PROJECT: Cross County School – Shop Addition **PROJECT NO.** L14057
FROM: BVH Architects **DATE:** 8/29/2014
TO: All Bidders **ADDENDUM NO.** 1

CROSS COUNTY SCHOOL - SHOP ADDITION

ADDENDUM #1 - ADD1.1

A1/A1.3 ROOF PLAN

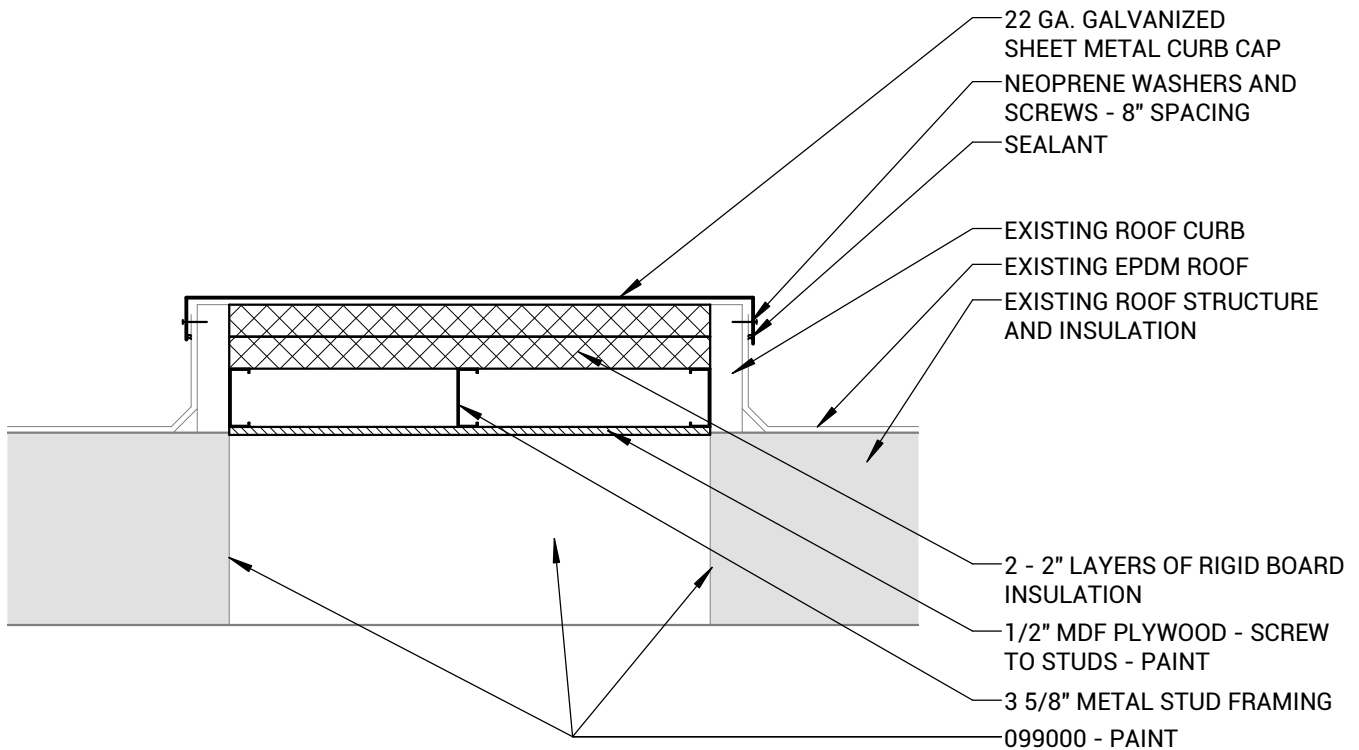
1. A1.1 – First Floor Plan
 - a. A1 First Floor Plan
 1. Adjust note for 'New 5" Conc Slab" to read 'New 6" Conc Slab, See Civil.'
2. A1.3 – Roof Plan
 - a. A1 Roof Plan
 1. See attached updated drawing ADD1.1 to infill the roof where exhaust hood is being removed.
 - b. L20 Existing Roof Infill – NEW DETAIL
 1. See attached new drawing ADD1.2 to infill the existing roof.
 - c. Sheet A1.3 between A1.4 and A2.1 is a duplicate and can be deleted.
